## COUNCIL ASSESSMENT REPORT

| <b>Panel Reference</b>   | <b>PPSSCC-81</b>  |
| <b>Proposed Development</b>  | Mixed Use Development including Commercial Floor Space and 77 Serviced Apartments and Alterations and Additions to an Existing Licenced Hotel   |
| <b>Street Address</b>  | 13-19 Lexington Drive Bella Vista   |

Figure 2: Axonometric diagram indicating circulation patterns

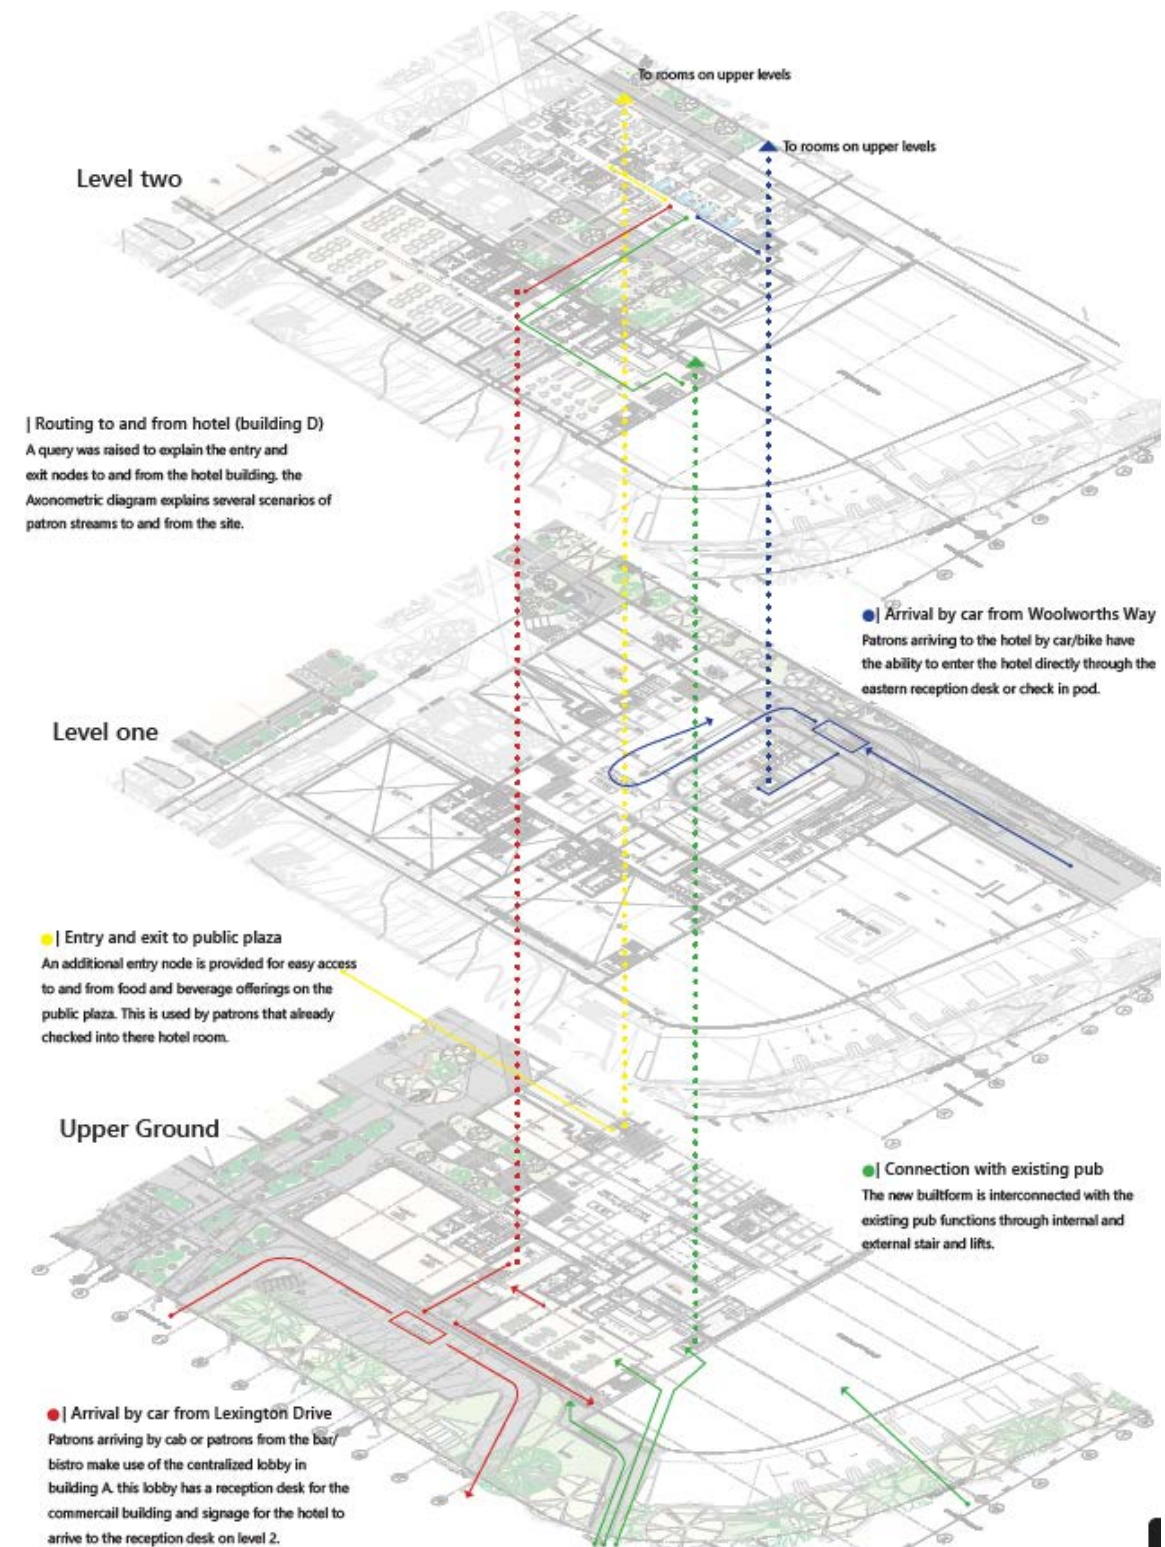
- Vehicular and pedestrian access provided is integrated with the landscape plan and results in a high quality landscaping outcome. Pedestrian/vehicular conflicts have been minimised.
- The proposal complies with the 20m front setback control as required under DCP 2012.
- An axonometric diagram has been included that indicates the ranges of uses and demonstrates the circulation patterns within the floorplans (see Figure 2 below).
